HVAC Flange, Installation  
CHU, CXU, GU, TD

## **FSB 873-020, HVAC Flange, Installation**

**(May 2016)**

W8112139

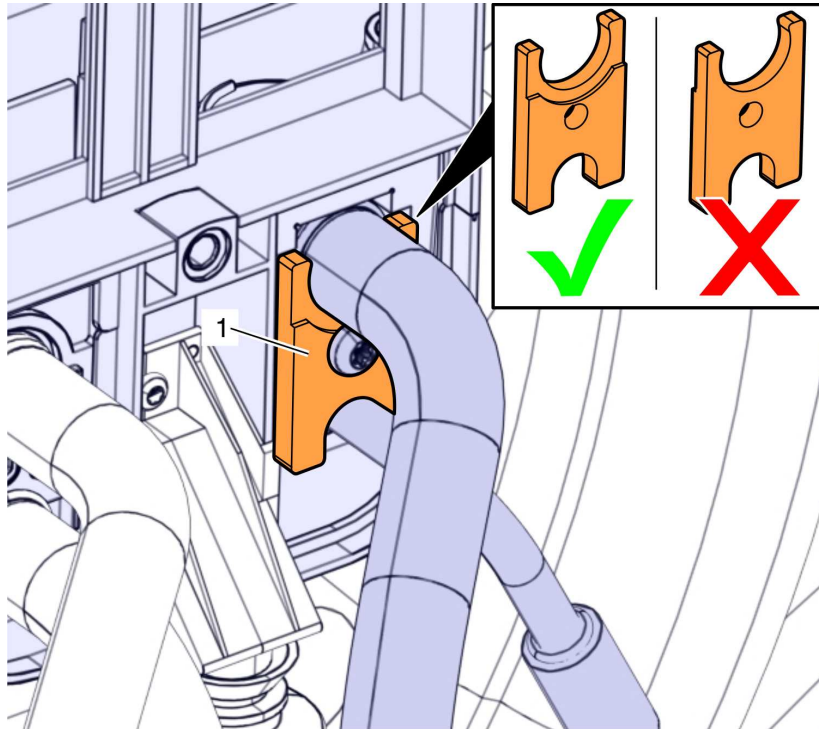
The new flange bracket used to secure the AC lines to the HVAC units (front and bunk) may be installed incorrectly starting in production week 1614. Follow the reference image in this Field Service Bulletin (FSB) to ensure proper installation of the HVAC flange bracket.

**Note:** The HVAC flange bracket should be installed with the machined Surface (1) facing away from the main and bunk climate unit as shown in the reference image.
